**Re: Christina Lake Thermal Project Phase H and Eastern Expansion
Project Update and Supplemental Information Request 2 Responses
AER Application No. 1758947
EPEA Application No. 019-48522**

The purpose of this document is to provide responses to the Round 2 SIR package and provide updated information regarding the Project (Project Update). This document is organized into two parts as follows:

LEGEND

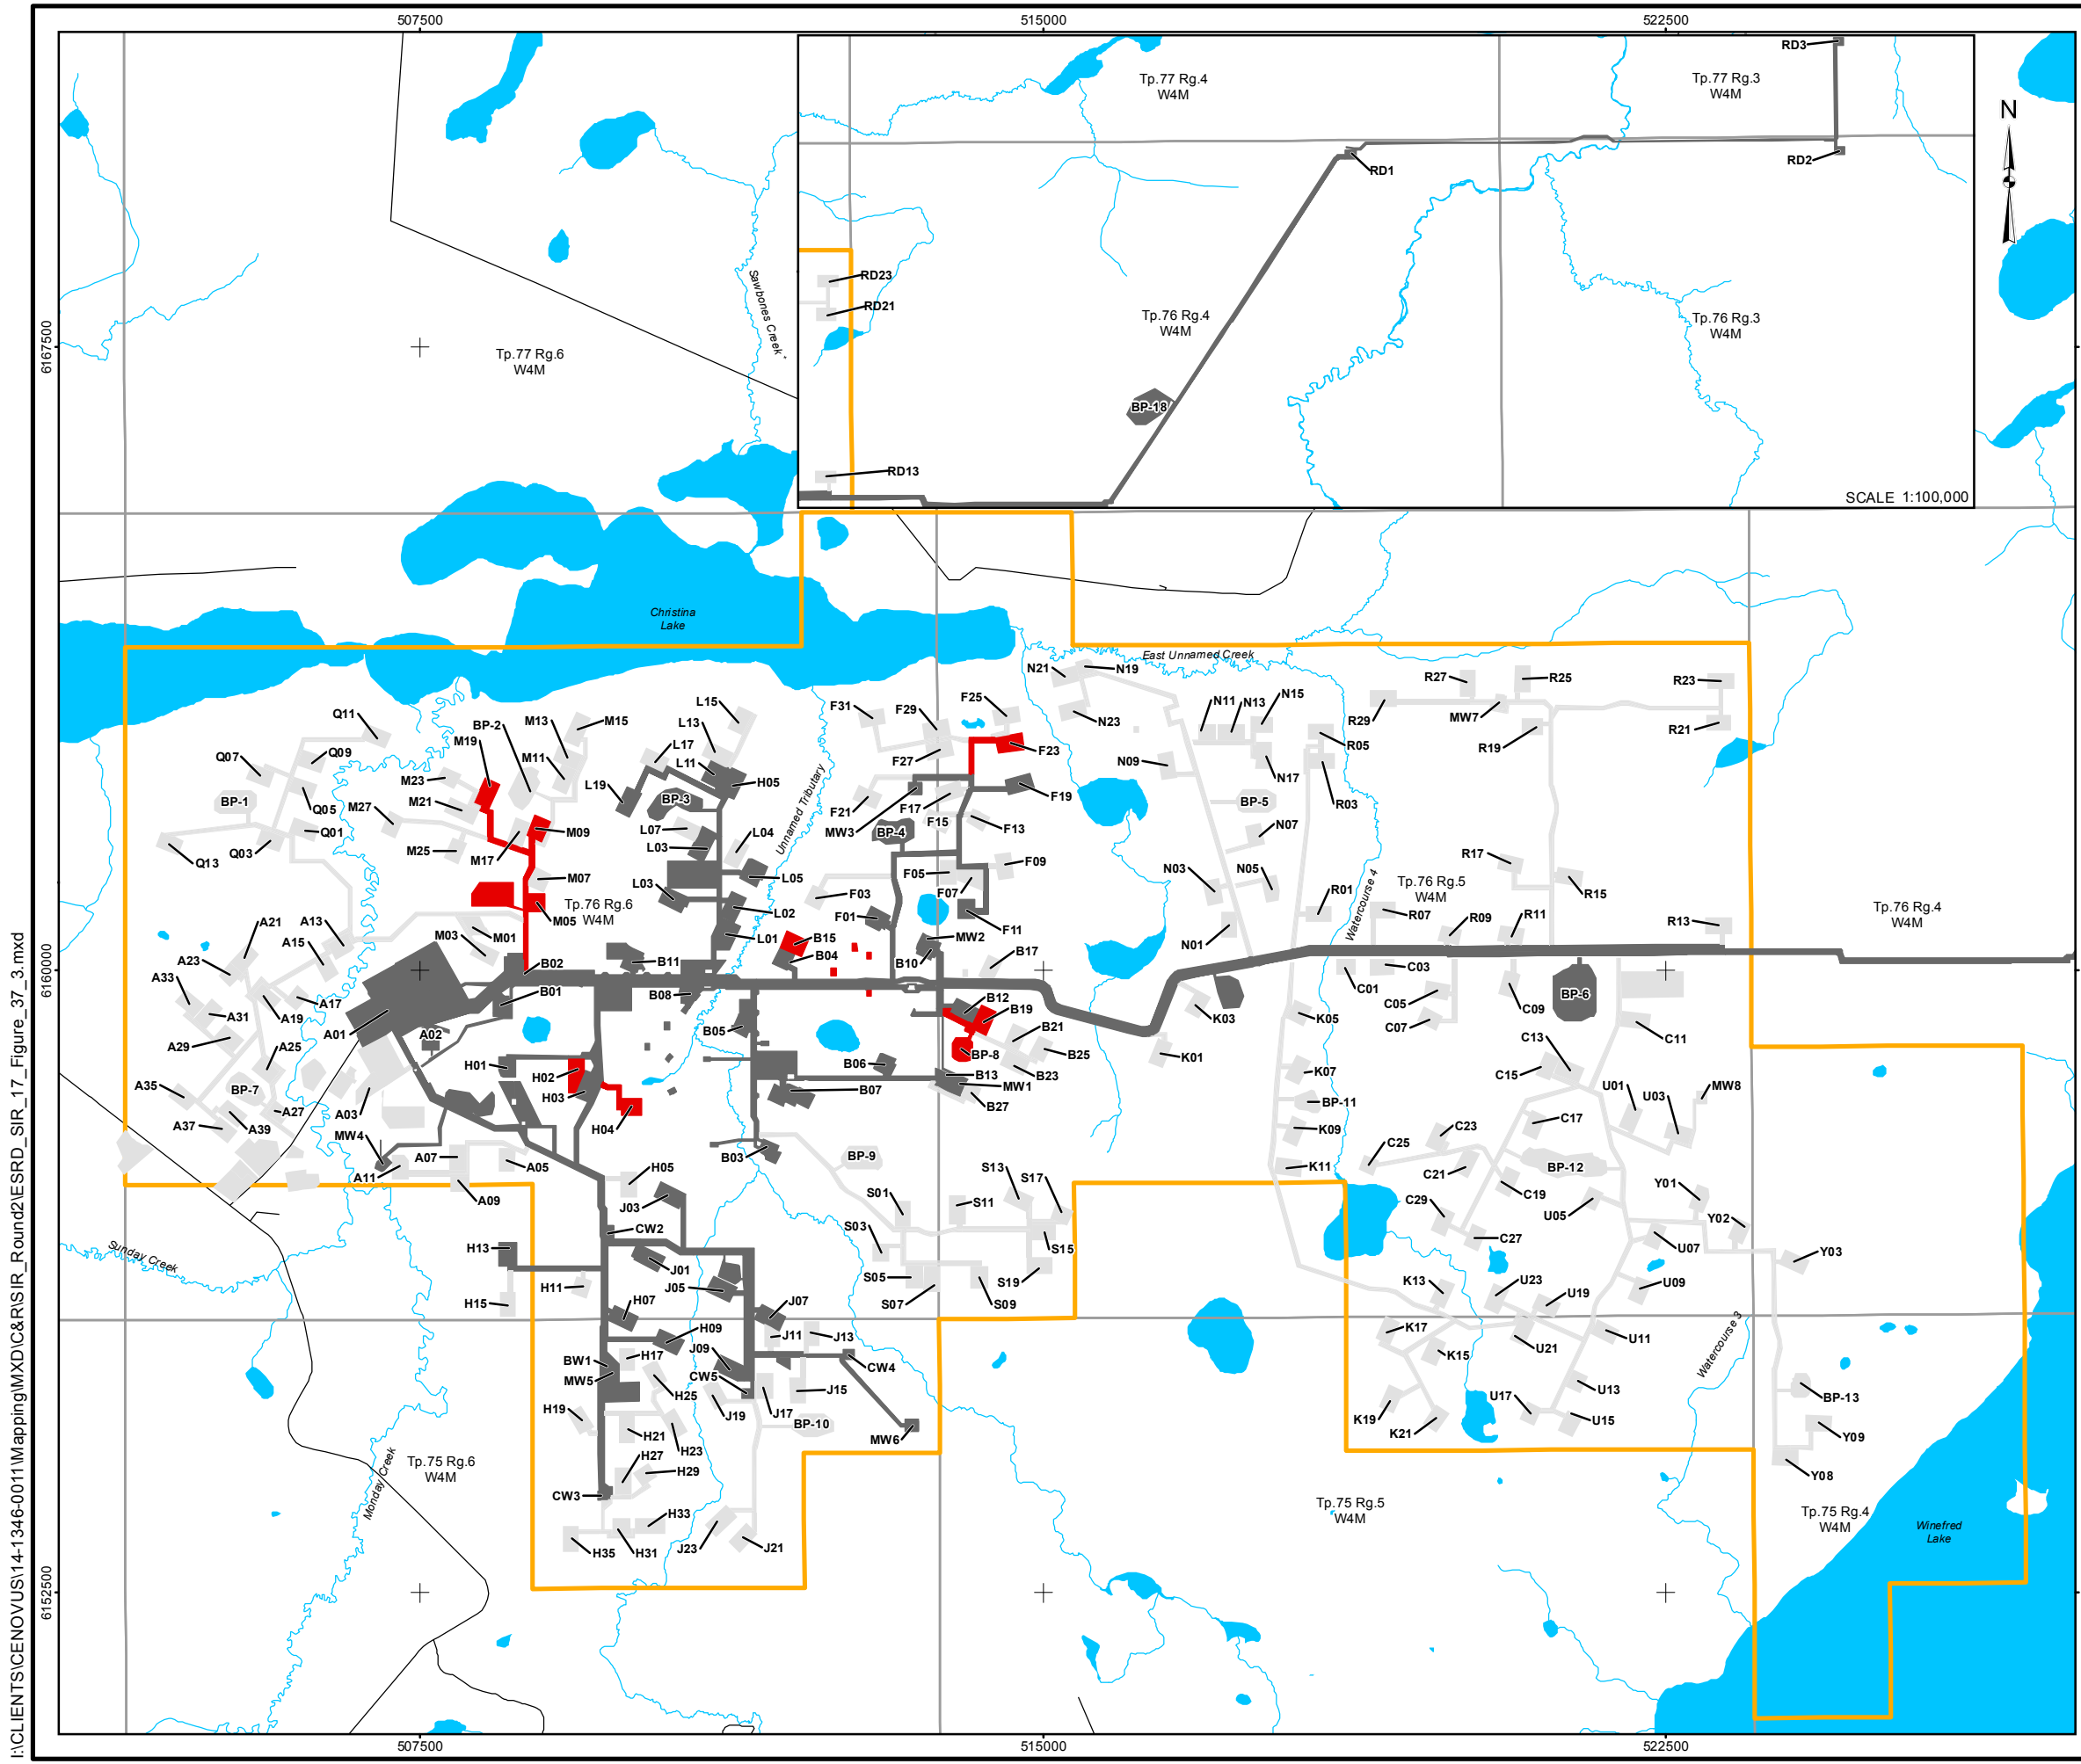
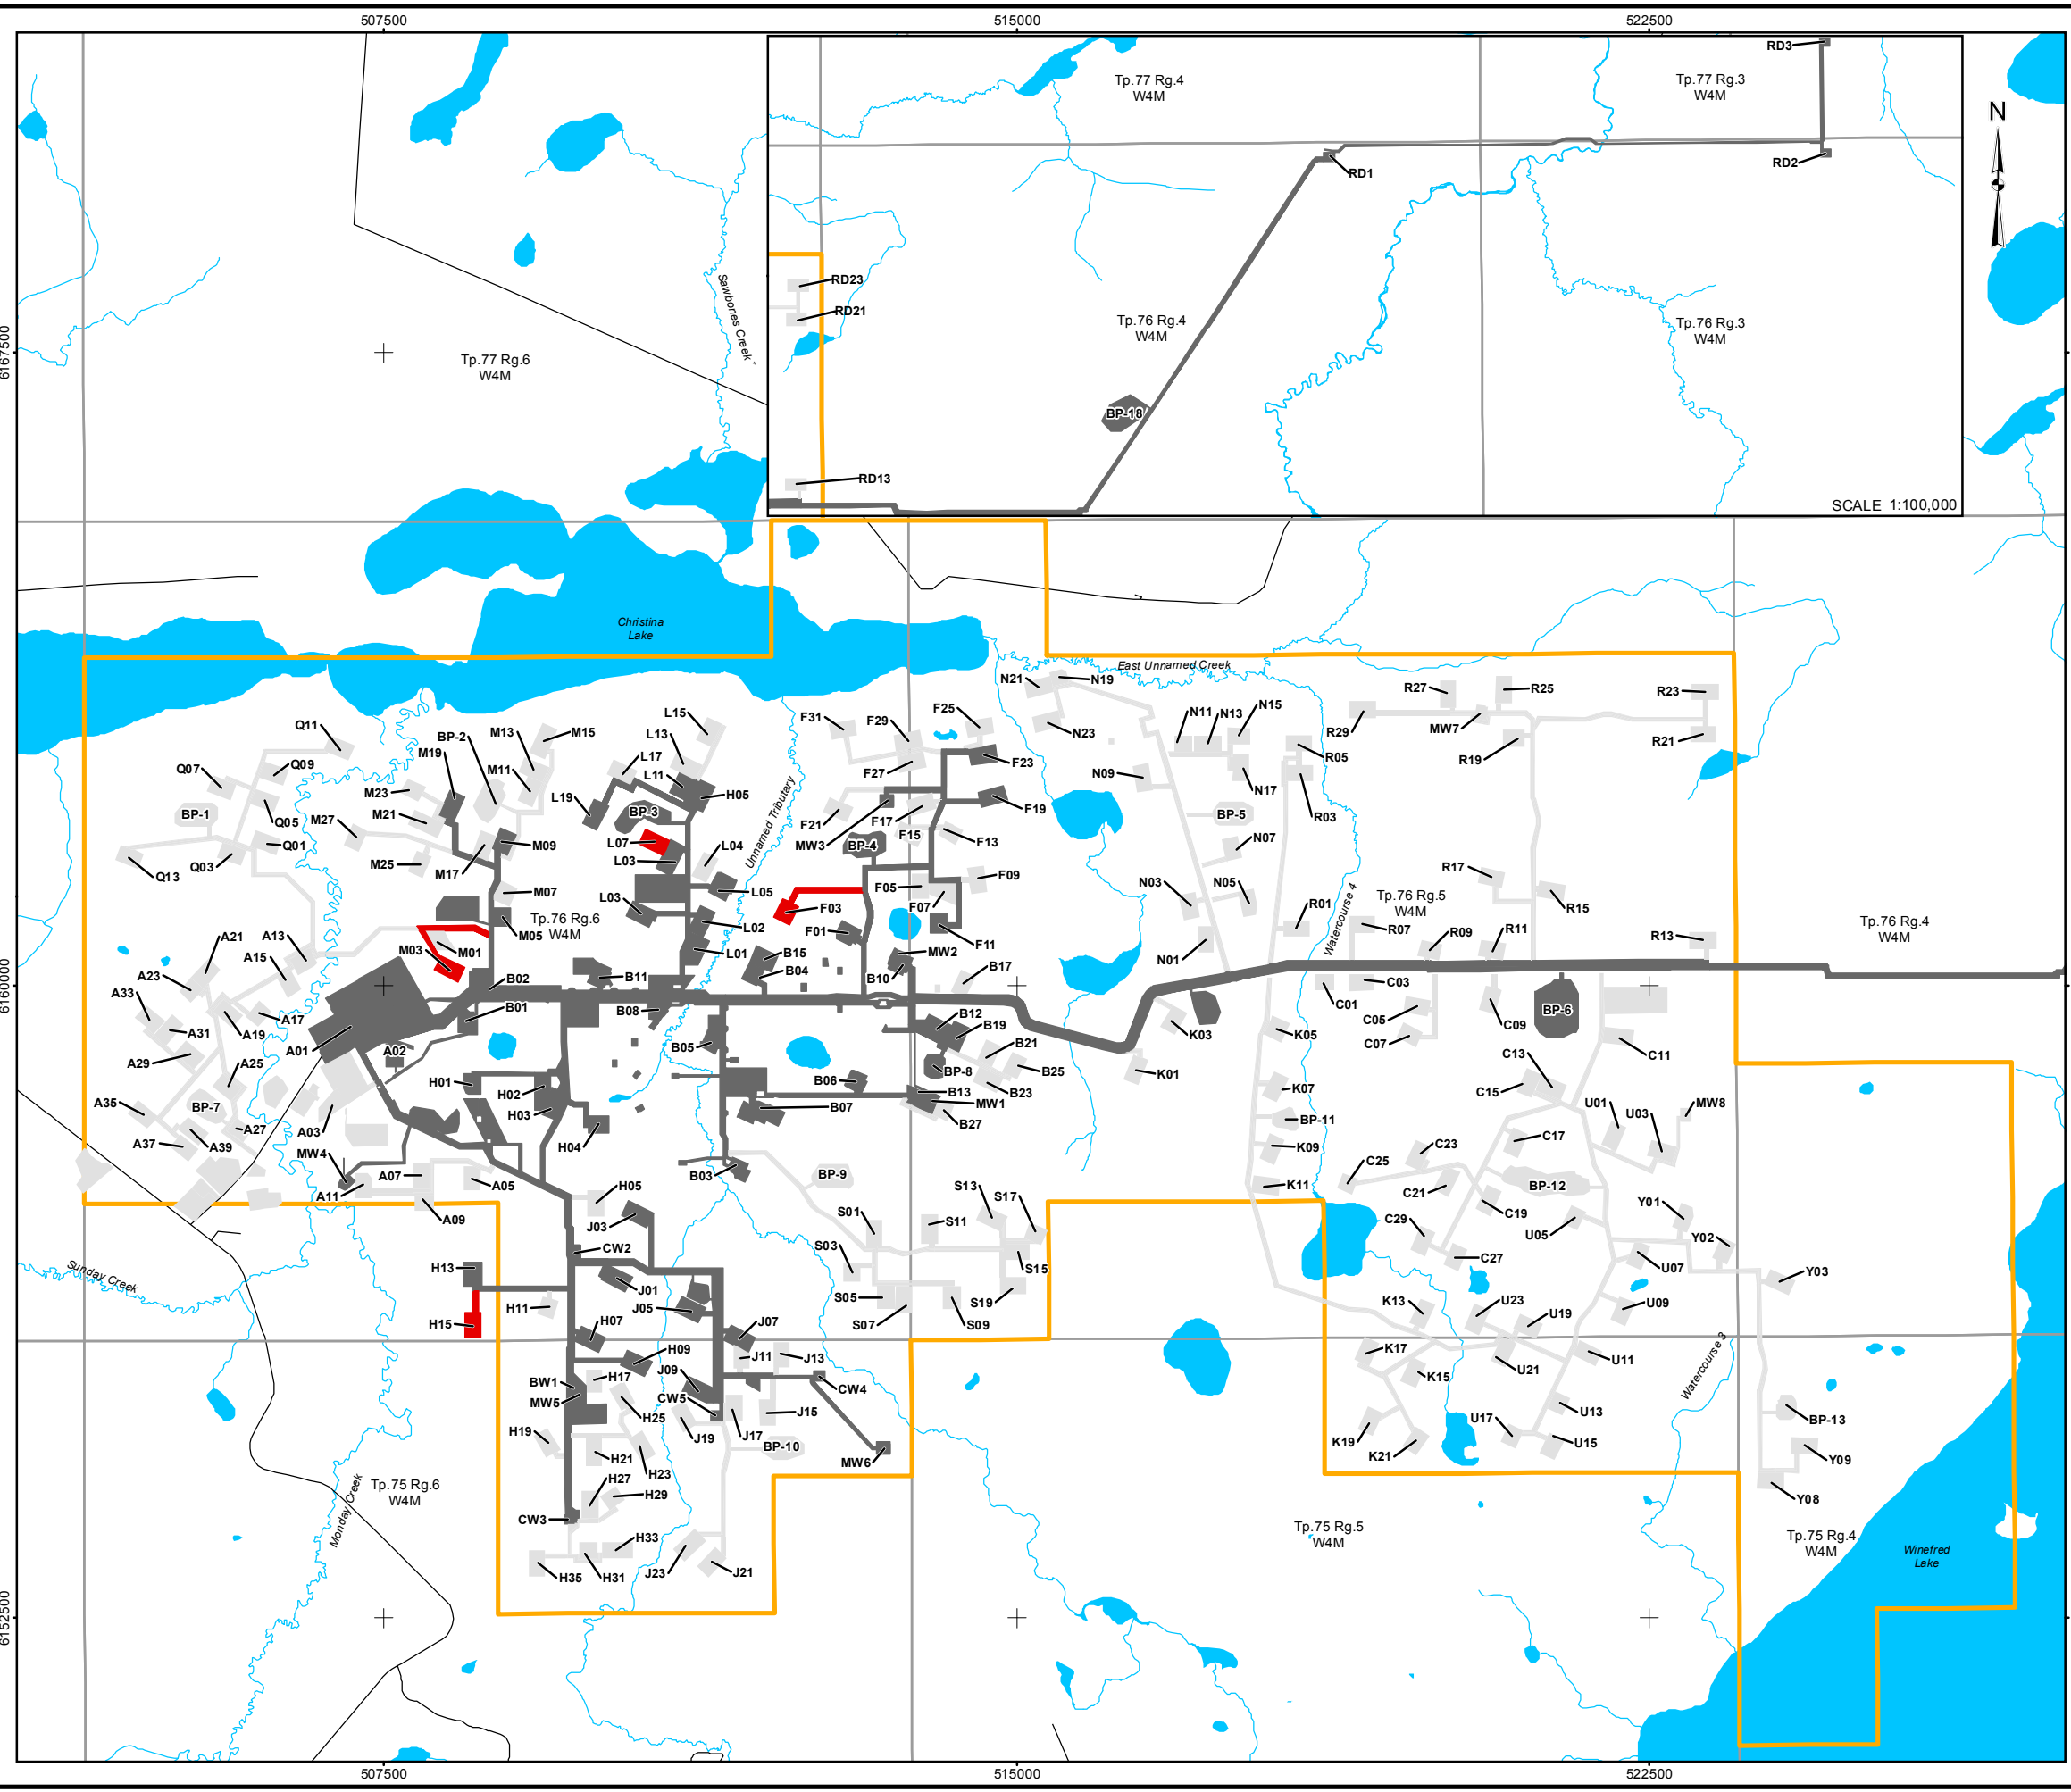
In Table 65-2, the column Unnamed (Monday) Creek appears to be mislabelled. All Figures in the SIR response 69 are mislabelled. In Figure 186-1, the sub-watershed is mislabelled.

Figures 69-1 to 69-13 from ESRD Round 1 SIR 69 have been revised and are presented as [Figures 37-1 to 37-13](#).
